UNITED STATES PATENT AND TRADEMARK OFFICE

Office Action Summary

10/539,036

DETAILED ACTION

FIG. 1

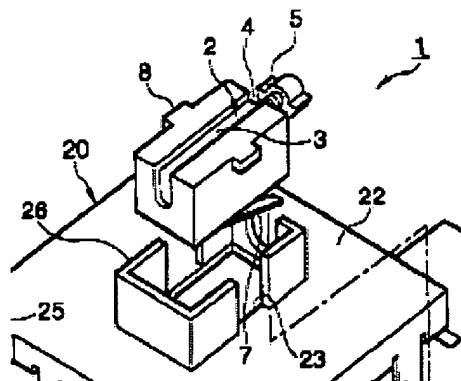
6. Claims 29 and 35 are rejected under 35 U.S.C. 102(a/e) as being anticipated by Sei et al. (US 6,542,381). Sei teaches a vibration motor comprised of a motor body 3 (Fig.1), a motor shaft 4 projecting from the motor body (Fig.2), an eccentric weight 5 attached to the motor shaft 4 (Fig.1), and an attaching means (shock absorber/motor-case) 8 for supporting said motor body 3 in a horizontal prone posture at one surface of a board (base/shield case) 20/22 (Fig.1; see also c.4:35-37 & c.4:48-53 teaching that shock absorber 8 attaches the vibrator by means of a force-fit into holder 26, so that the motor 3 is in a horizontal prone posture at one surface of board 20/22), wherein the attaching means has a pair of attachment faces (not numbered, ‘tabs’ extending from either side of shock absorber/motor-case 8) straddling said motor shaft 4 and

extending in parallel with the same at the two sides of a motor case 8 (Fig. 1; c. 4:35-37&48-53) and a plane including said pair of attachment faces intersects with a circular orbit of the outermost point of the eccentric weight 5 at two points (i.e., a plane passing through 'tabs' inherently intersects with a circular orbit of the outermost point of eccentric 5 at two points on the plane since the eccentric 5 including its outermost point rotates through the plane, perpendicularly to it, as seen in Figs. 1&2, and thus intersects with the plane at two points).

Regarding claim 35, the attachment faces (tabs or shock absorber/motor case 8) are shaped such that they can be considered "rails" (Fig. 1).

8. Claims 30 and 36 are rejected under 35 U.S.C. 103(a) as being unpatentable over Sei et al. In Fig.1, Sei does not specify that the pair of attachment faces/tabs are positioned closer to the eccentric weight 5 than to a center of gravity of said vibration motor. However, merely repositioning the faces 8 would have been obvious since it has been held that shifting location of parts involves routine skill. In re Japikse, 86 USPQ 70.

Regarding claims 34 and 40, Sei's attachment means (shock absorber/motor case) 8 comprises attachment faces/tabs extending from both sides at the top thereof (not numbered, Fig.1). With this in mind, it cannot be deduced from Fig.2 that the attachment faces/tabs "[affix] to one surface of said board at the sides of said cutaway space or said open space, and

12. Regarding the rejection over Sei et al. (US 6,542,381), the examiner notes that the “shock absorber” 8 comprises a ‘housing’ or ‘case’ as applicant argues; however, it also comprises ‘tabs’ (applicant’s term) which extend from its side. Although not numbered, these ‘tabs’ are clearly shown in Fig.1 (they are also shown in Prior Art Fig.3A as part of the “shock absorber” 51). Drawings and pictures can anticipate claims if they clearly show the structure which is claimed. *In re Mraz*, 455 F.2d 1069, 173 USPQ 25 (CCPA 1972). The ‘tabs’ comprise “attachment means” since they are part of the “shock absorber” 8 disclosed as attaching the vibrator by means of a force-fit into holder 26, so that the motor 3 is in a horizontal prone posture at one surface of board 20/22 (c.4:35-37). Further, as can be readily seen in Fig.1, the tabs slide into respective slots (not numbered) on either side of holder 26 in which the vibrator is “forced” and “held” (c.4:35-37). Sei teaches that the walls of the holder are formed in

FIG. 2

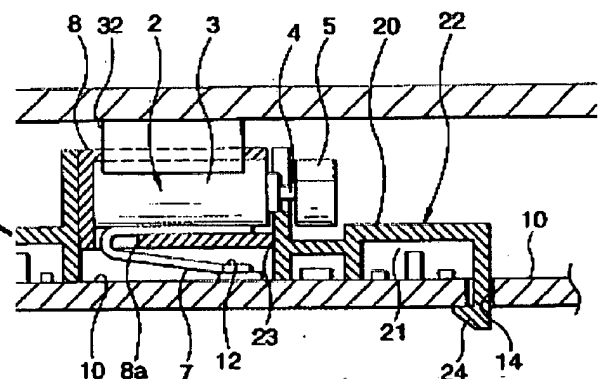
said vibration motor is mounted with at least said motor body in a state sunken in said cutaway space or said open space” since it appears that the attachment faces/tabs would be located some distance above the surface of the circuit board (base/shield case) 20/22.
